Final Programmatic **Environmental Impact Statement**

related to decontamination and disposal
of radioactive wastes resulting from
March 28, 1979, accident
Three Mile Island Nuclear Station, Unit 2

Docket No. 50-320

U.S. Nuclear Regulatory Commission

Figure 6.4-1 Flow Diagram for Purge Using Charcoal Adsorption System

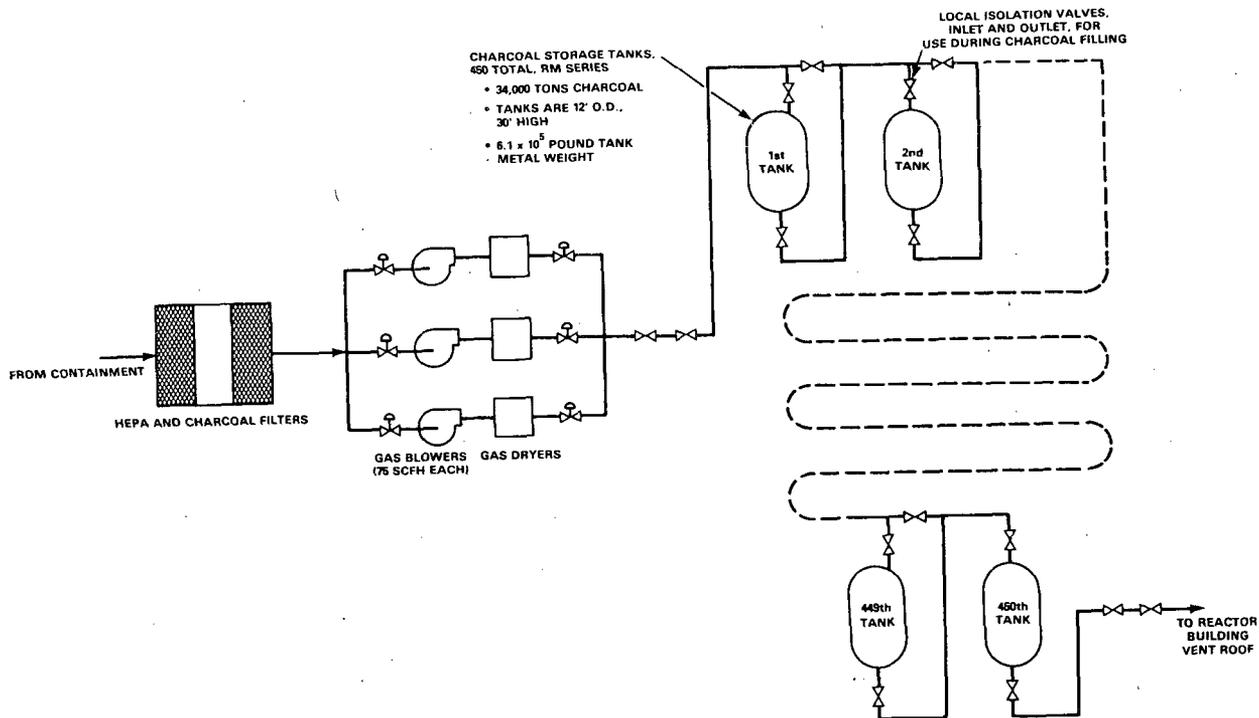
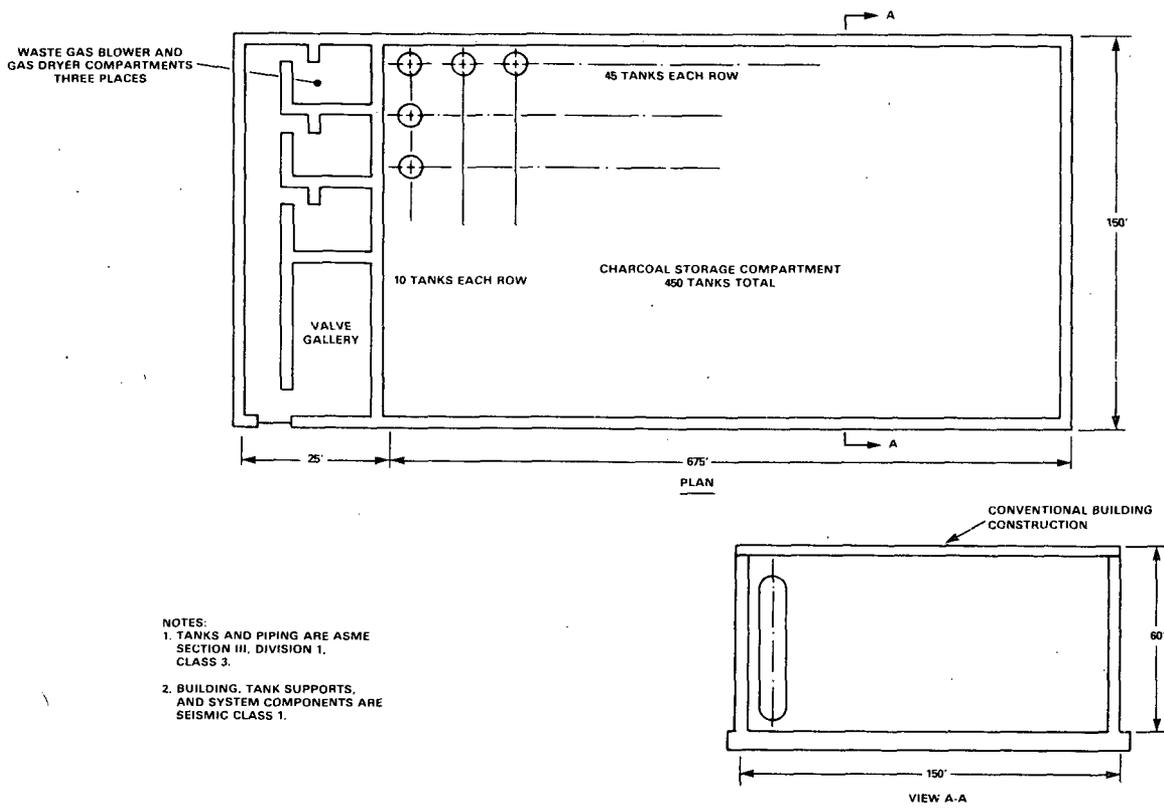
MW = Monitoring Well (pumped samples)
49. Figure 6.4-1
Figure 6.4-2 - The inclusion of these figures should not preclude alternative designs. The reference to 'air tight' doors on the figures should be deleted.
